Simplified classification in the State Diagram v110

Fixes to the Type 3/4 PSE state diagram

Simplified classification

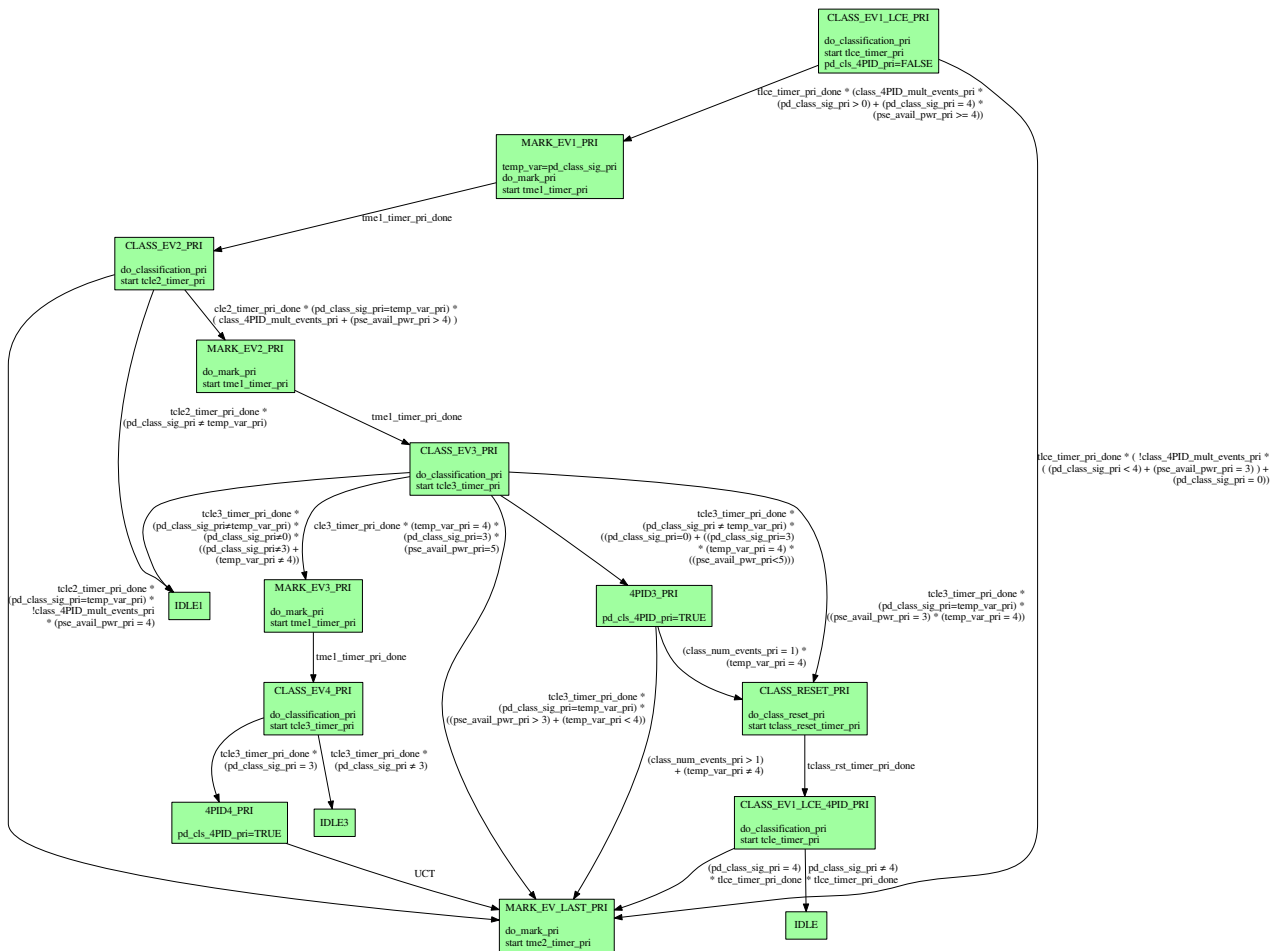
Remove the states CLASS_EVAL and POWER_DENIED (including in and outgoing arcs) from Figure 33–15.

Change Figure 33–15 as follows:

FROM state	TO state	Change
POWER_ON	IDLE	(tmpdo_timer_done + !power_available) * !short_det_pri * !ovld_det_pri * !option_vport_lim_pri * !short_det_sec * !ovld_det_sec * !option_vport_lim_sec * power_available
